INQUIRY INTO RURAL WIND FARMS

Kyoto Energy Park Scone

Response to Questions raised by Keith
Thompson and Iris McPhee 'Peakhill' at
Winters Rd, Scone.

Background Measurements- Wilkinson Murray Pty Ltd (Peakhill 2007)

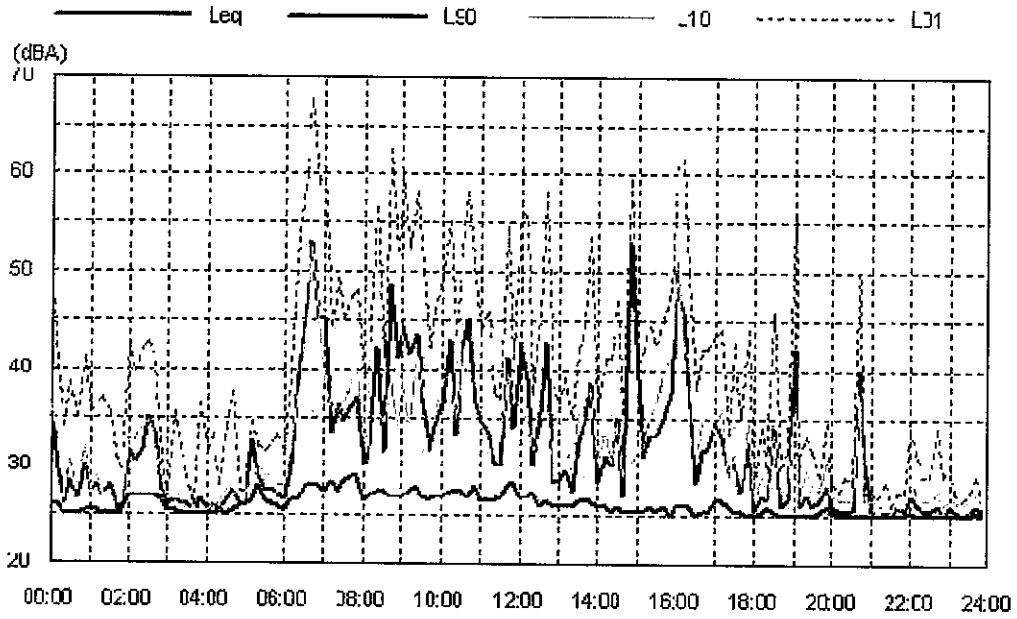
2) The 'DbA' readings that were taken in 2007 & promised to be available to us before Xmas 2007. Note, we require hourly daytime as well as hourly night time readings. Also info about the wind speed each hour, was it raining at each hour ?

Background noise measurements were taken in May/June 2007 and Sept/Oct 2007. The Noise Assessment was completed in August 2008. We have supplied the background noise levels taken at your residence – see attached. As described in our meeting with you on the 15th December 2008 noise will be kept within criteria at your residence through sector management of the turbines along Moobi Plateau. 4 turbines were removed from the original layout to reduce noise levels to within acceptable.
